X-600 firmware version cMT2078X-3.03

This zipped folder contains the files and instructions to upgrade your X-600 fluxer with the current firmware (operating system) version 3.03.

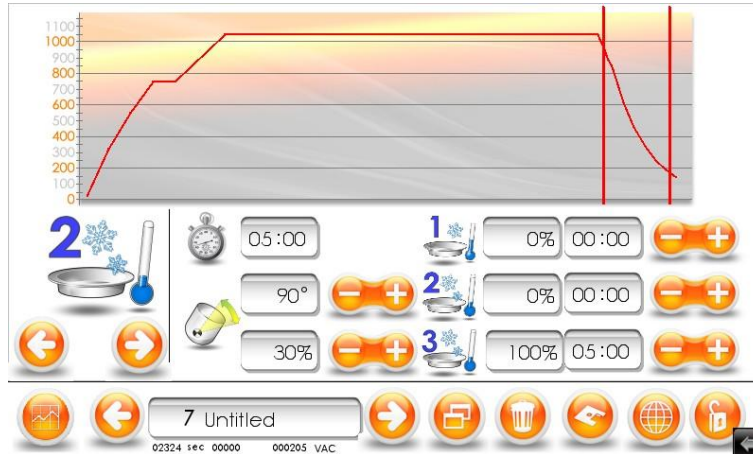
- New "Data Sampling" feature added. It gives the ability to log every fusion cycle with the samples IDs and generate a report for each day, up to a possibility of 40 days data recovery. The data sampling activation can be done by unlocking the system (password 2014) and it is located in the global parameters. A button will appear in the main window to access the data sampling window.

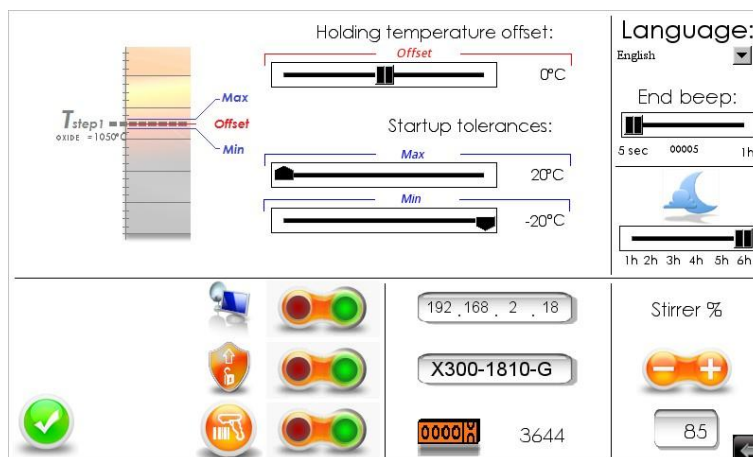
- New information fields, showing the serial number of the unit and the fusion counter in the global parameter window.

- Various labels in the global parameter window have been replaced by icons in order to reduce the amount of text. The "security shield" and the "moon crescent" icons are linked with the same feature as before (i.e. activating/deactivating the security shield in order to start a fusion, and setting the delay for an automatic shutdown to occur, respectively).
